BURLINGTON DEVELOPMENT REVIEW BOARD

Tuesday June 3, 2014

MEMORANDUM

To: Development Review Board
From: Mary O'Neil, AICP, Senior Planner *MO*
Date: June 3, 2014
RE: ZP 13-0650CA/MA 110 Riverside Avenue

PROPOSED WEST ELEVATION

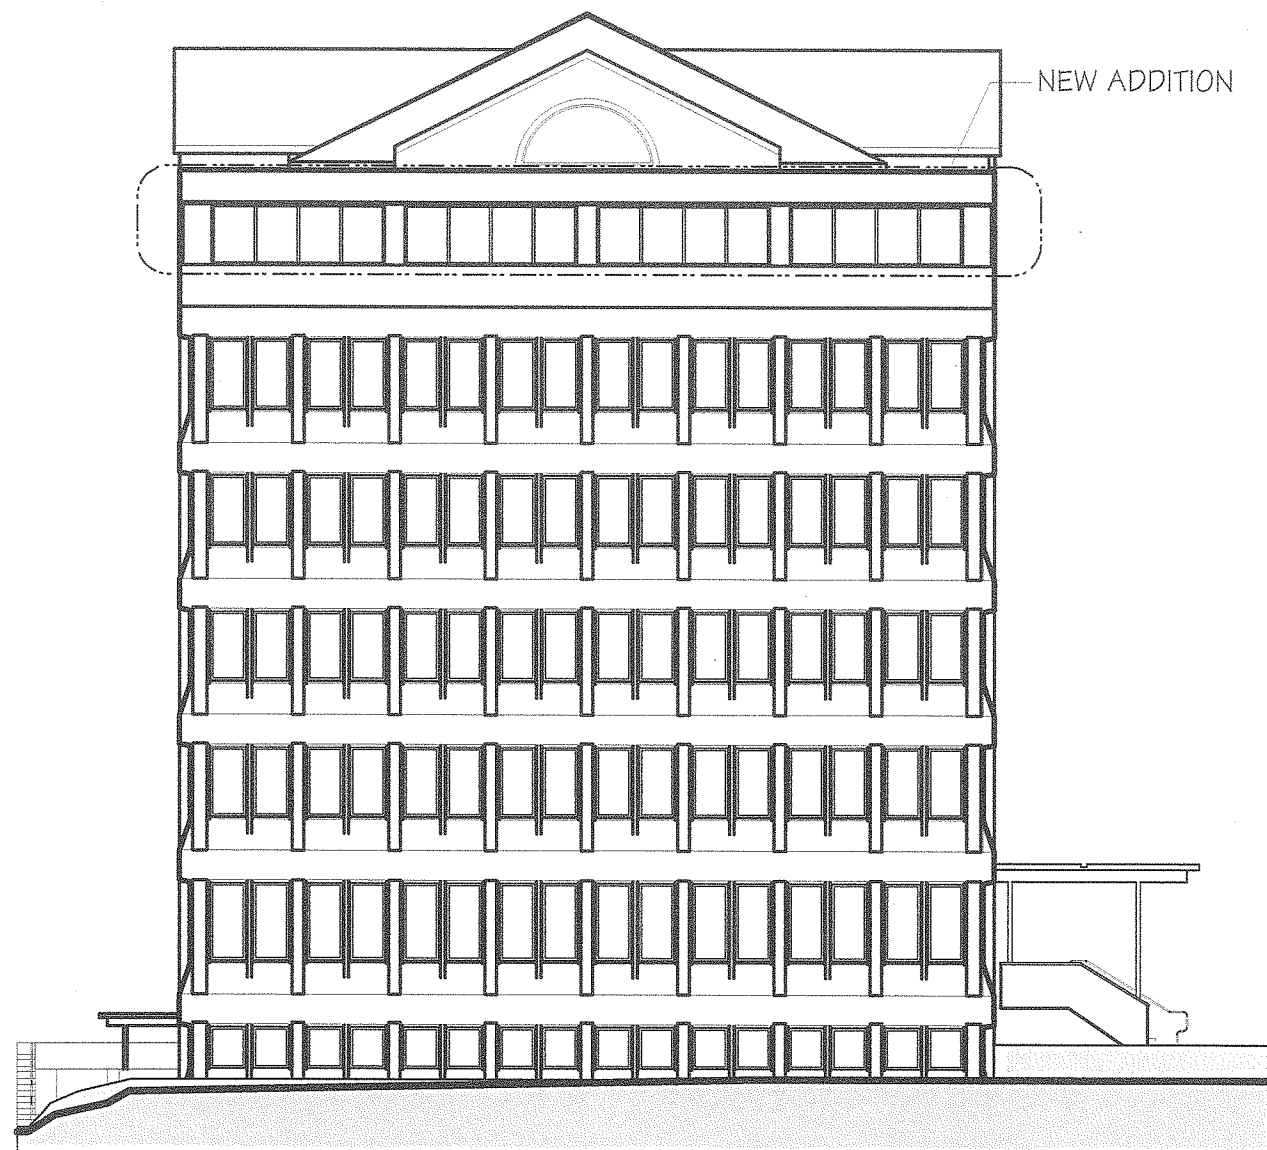
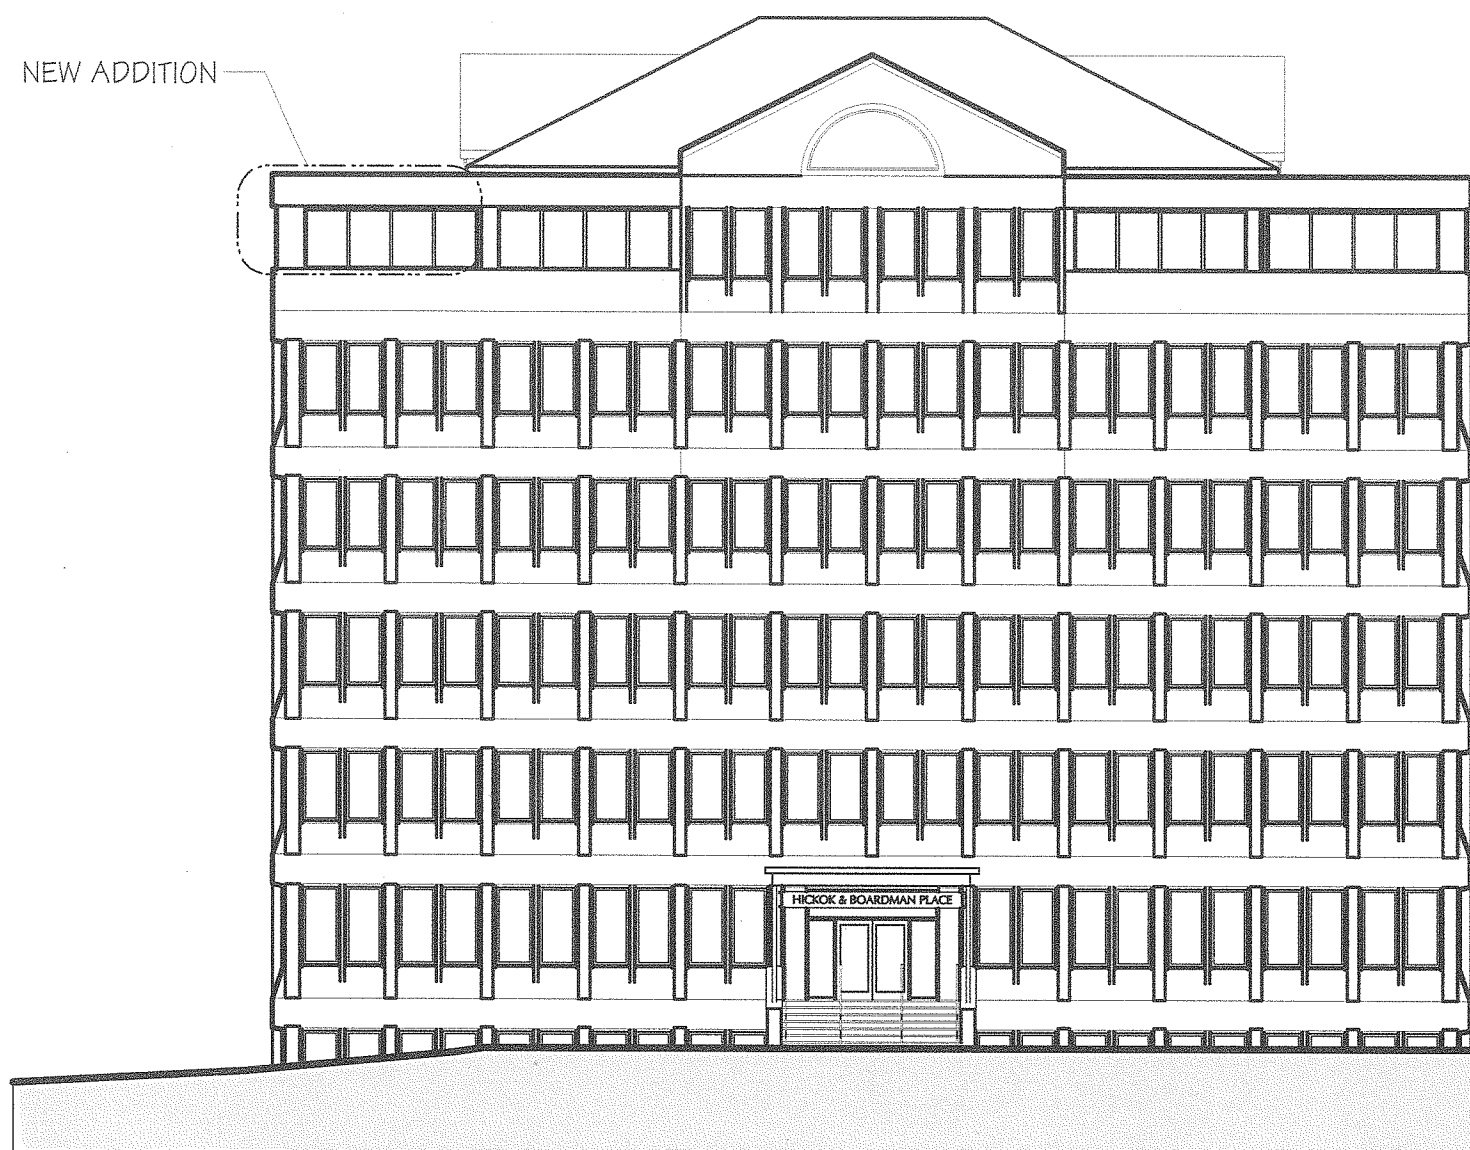
Exterior building materials are not noted and must be. The project plans suggest that materials will match the dark metal paneling on the existing 6th story office space. Likewise, proposed windows appear to match existing windows, but material details are needed. **(Affirmative finding as conditioned)**

1. **Prior to release of the zoning permit**, revised building elevations noting exterior building and window materials shall be submitted, subject to staff review and approval.
2. At least **7 days prior to the issuance of a certificate of occupancy**, the applicant shall pay to the Treasurer's Office the impact fee as calculated by staff based on the net new square footage of the proposed development.
3. A State of Vermont wastewater permit may be required.
4. The proposed addition shall comply with Burlington's current energy efficiency standards and with Burlington's current egress requirements as established by Burlington Electric Department and Burlington Public Works, respectively.
5. Standard permit conditions 1 -15.

September 22, 10 a.m. - Existing

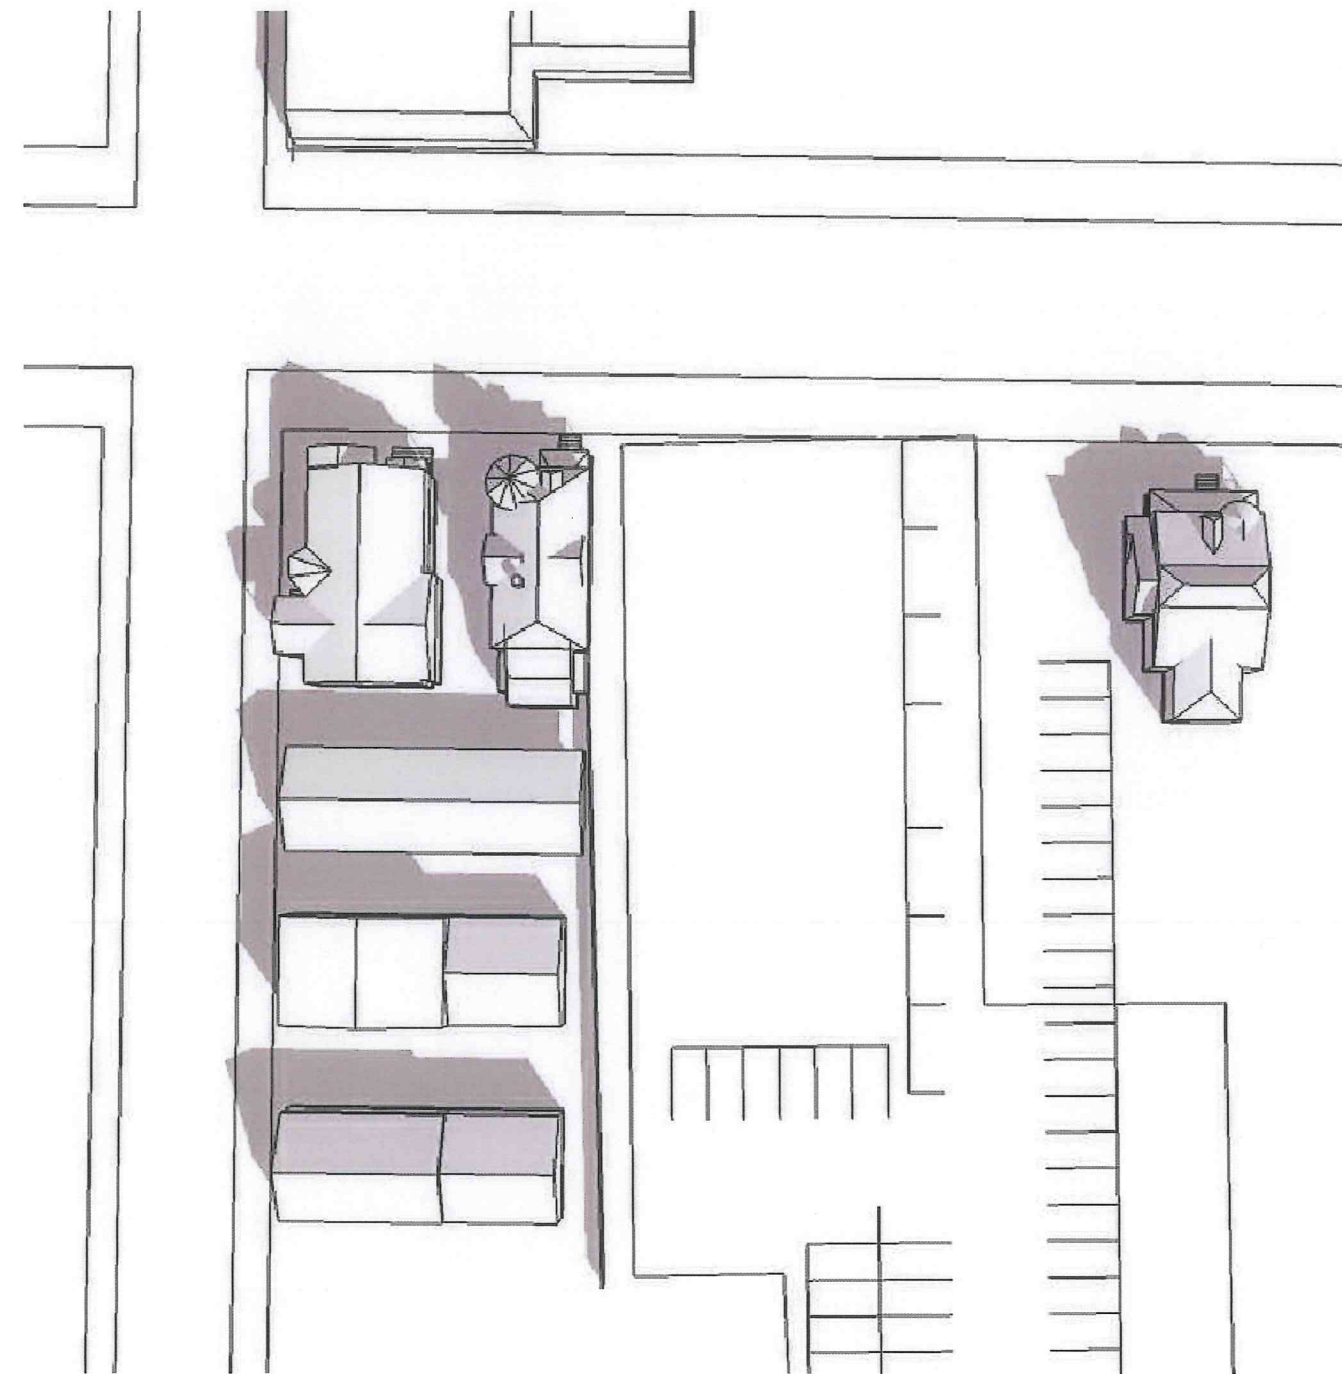
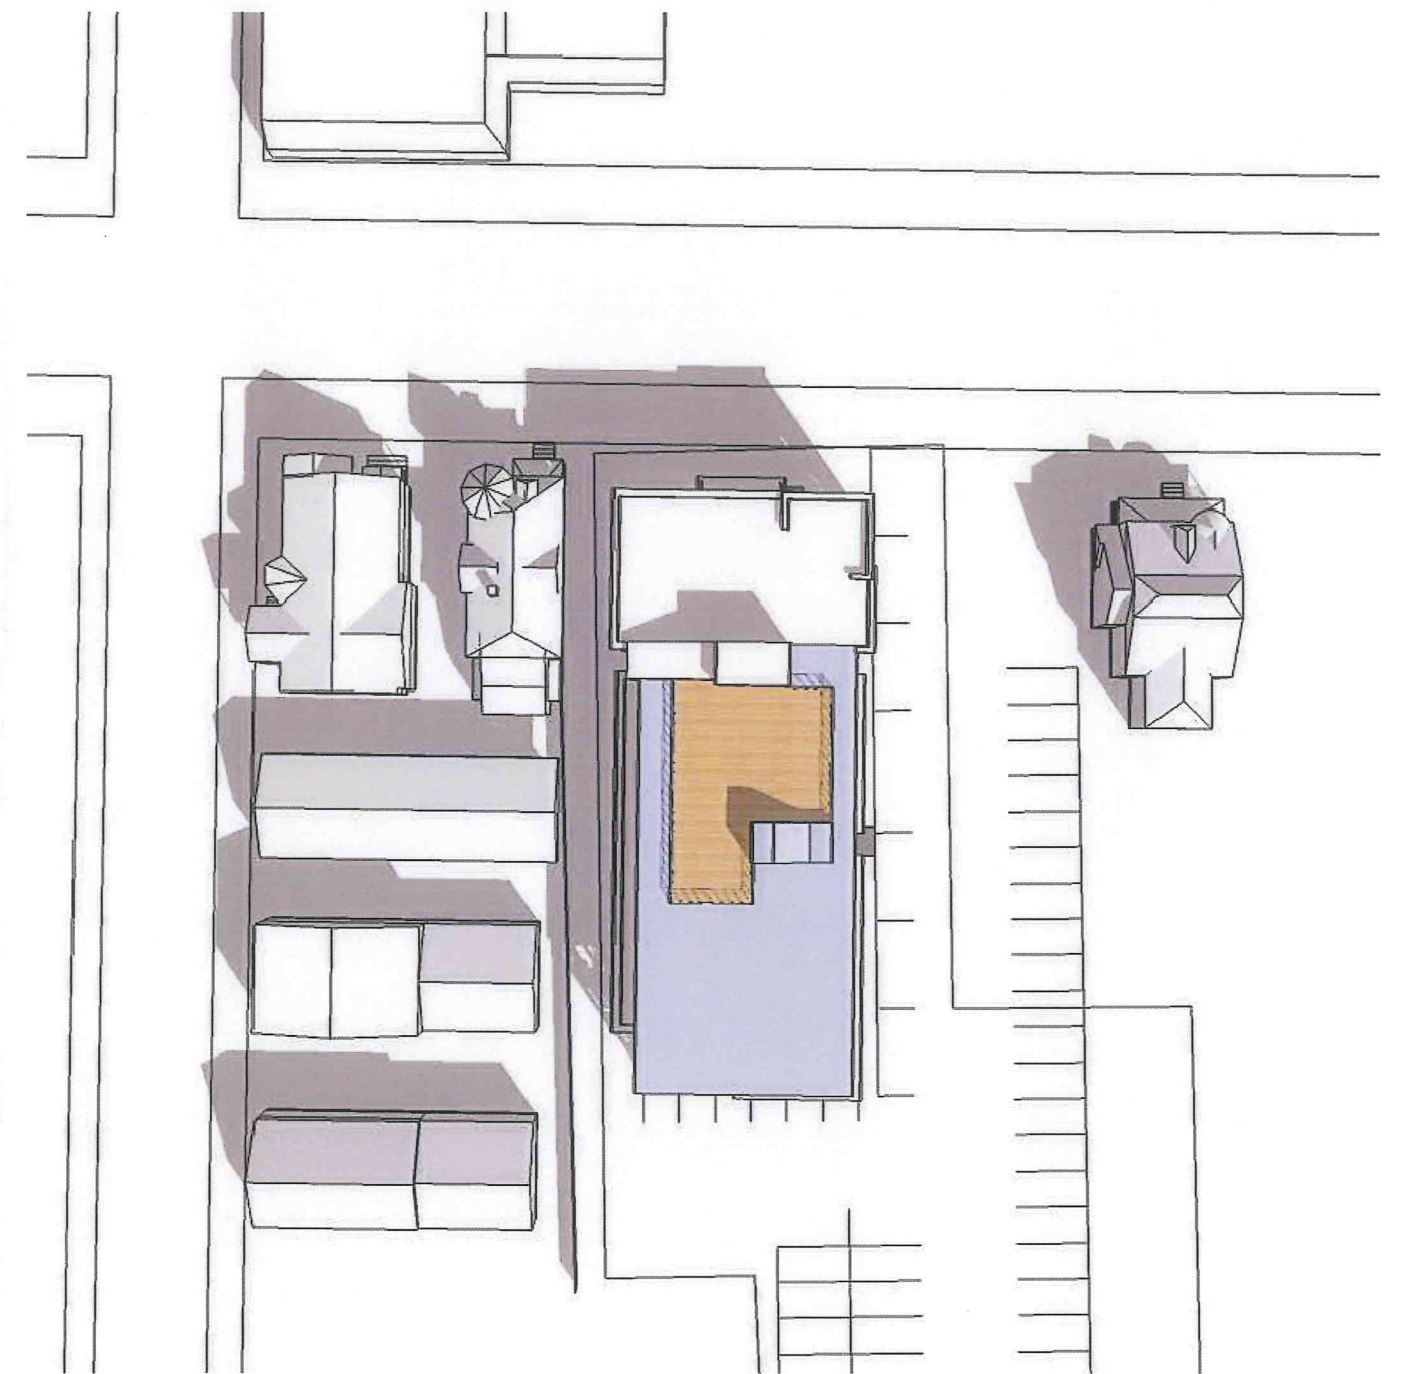
A shading plan has been submitted. Limited shading will be experienced by South Union Street abutters at the autumnal equinox; impacts subsiding by 10:00 am. **Affirmative finding.**
